Transmit PSD mask (Comment #290)

Gerrit den Besten

Vancouver, 11-14 March 2019

PSD shapes with current PSD mask

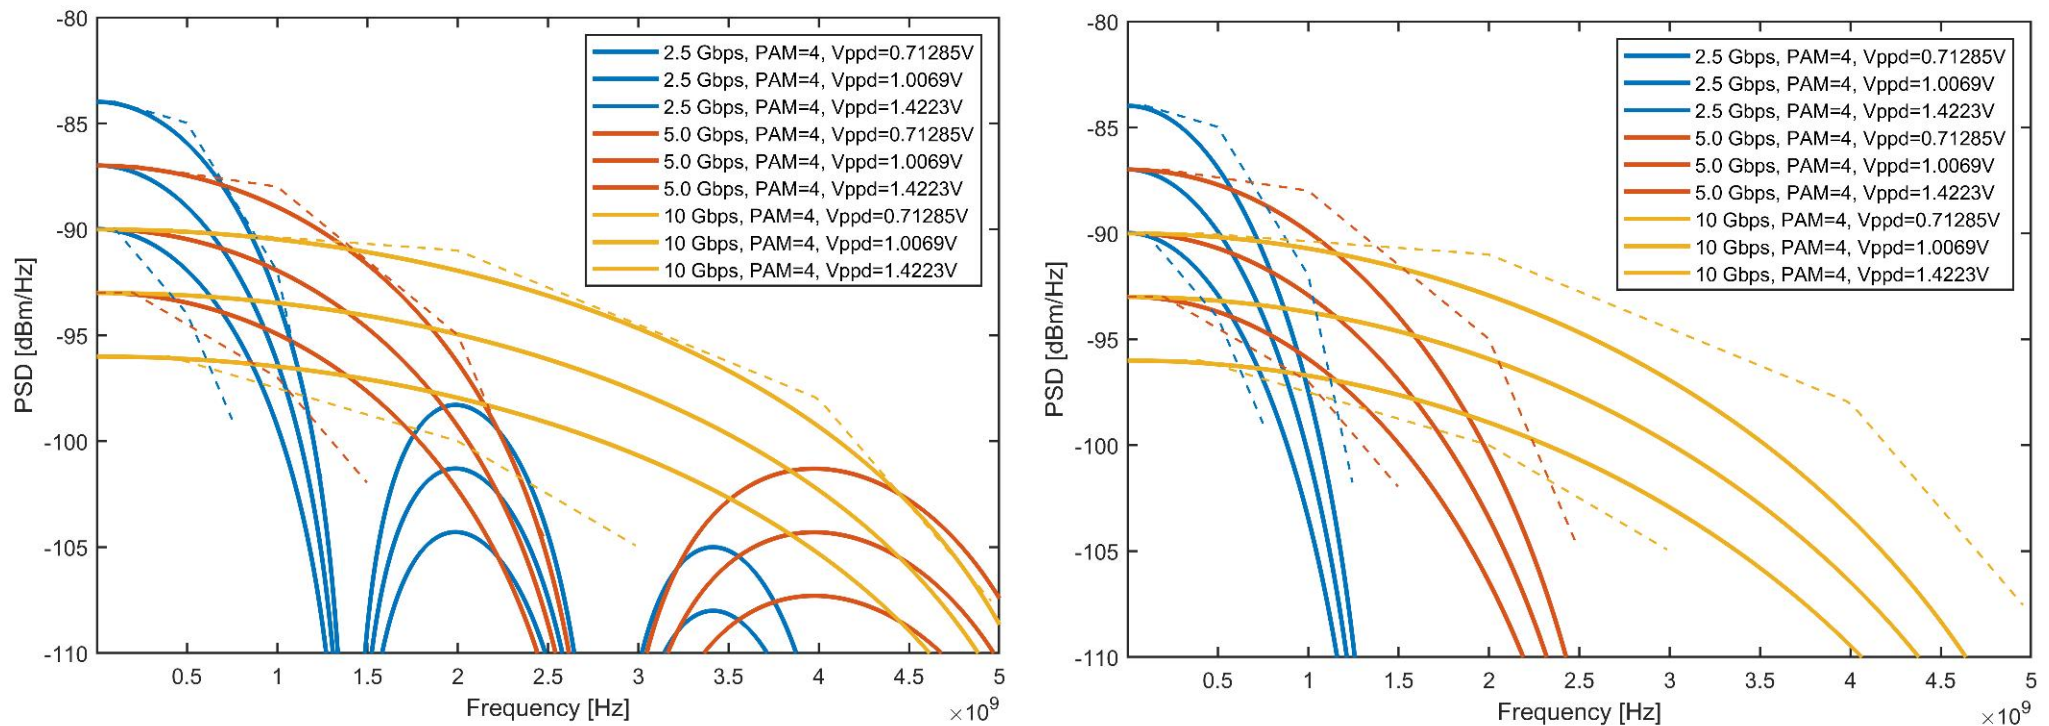
- ▶ Actual PSD shape shown for steep and smooth edges
- ▶ Current upper limit does not follow 'native' PSD shape
- ▶ PSD over the limit <2GHz for +3dB (implicit constraint)
- ▶ Limit above 2GHz is practically meaningless here

PSD shapes with proposed PSD mask

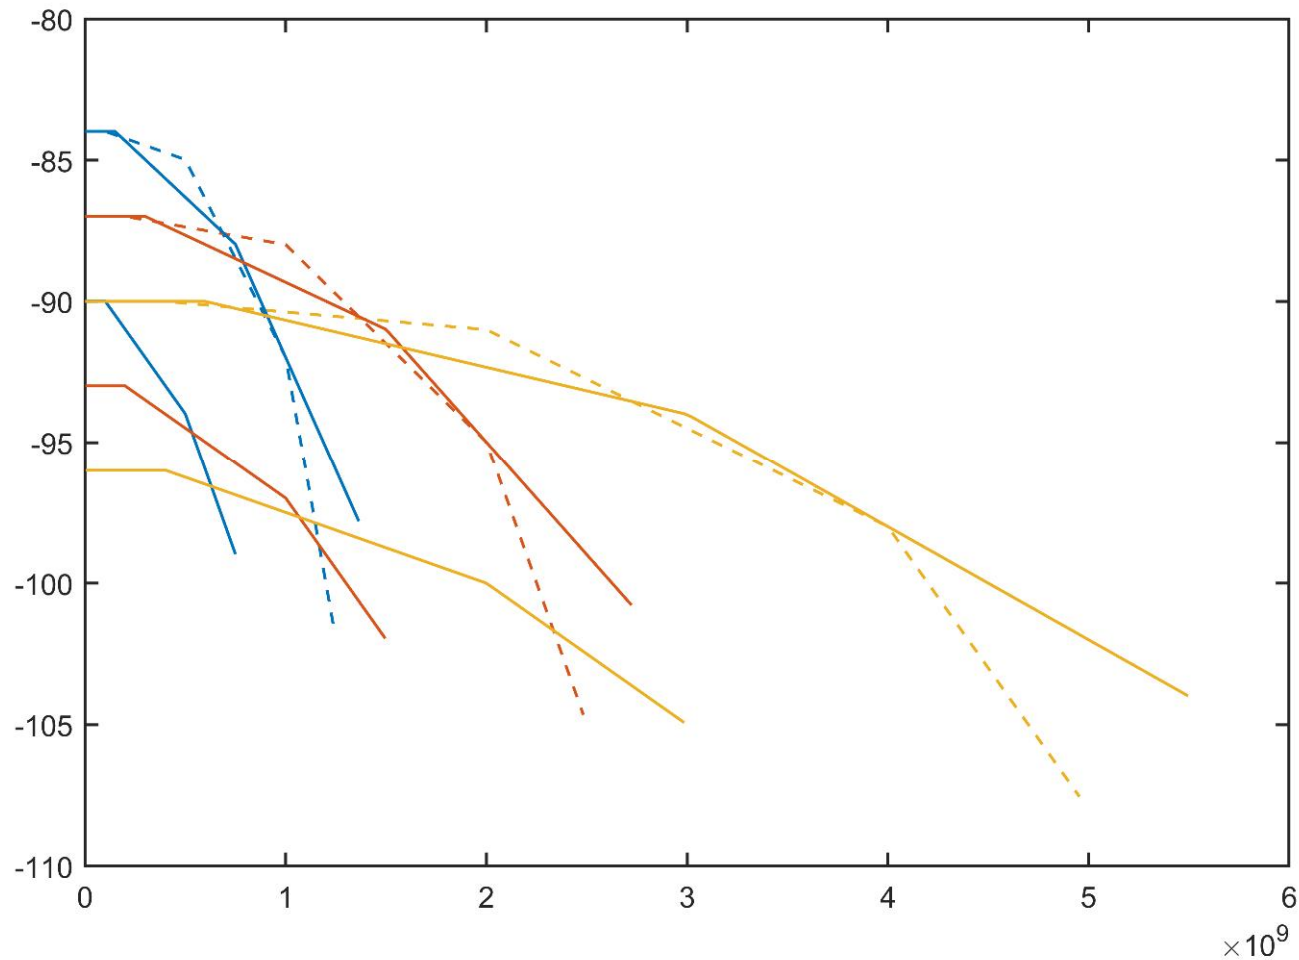
- ▶ Actual PSD shape shown for steep and smooth edges
- ▶ Proposed upper limit follows 'native' PSD shape

- Looser < 3S GHz, tighter >4S GHz

$$\left\{ \begin{array}{lll} -90 - K & \text{dBm / Hz} & 1 < f \leq 400 \cdot S \\ -90 - K - \frac{f - 400 \cdot S}{1600 \cdot S} & \text{dBm / Hz} & 400 \cdot S < f \leq 2000 \cdot S \\ -91 - K - \frac{f - 2000 \cdot S}{2000 \cdot S / 7} & \text{dBm / Hz} & 2000 \cdot S < f \leq 4000 \cdot S \\ -98 - K - \frac{f - 4000 \cdot S}{100 \cdot S} & \text{dBm / Hz} & 4000 \cdot S < f \leq 5000 \cdot S \end{array} \right.$$

$$\left\{ \begin{array}{lll} -96 - K & \text{dBm / Hz} & 5 < f \leq 400 \cdot S \\ -96 - K - \frac{f - 400 \cdot S}{400 \cdot S} & \text{dBm / Hz} & 400 \cdot S < f \leq 2000 \cdot S \\ -100 - K - \frac{f - 2000 \cdot S}{200 \cdot S} & \text{dBm / Hz} & 2000 \cdot S < f \leq 3000 \cdot S \end{array} \right.$$
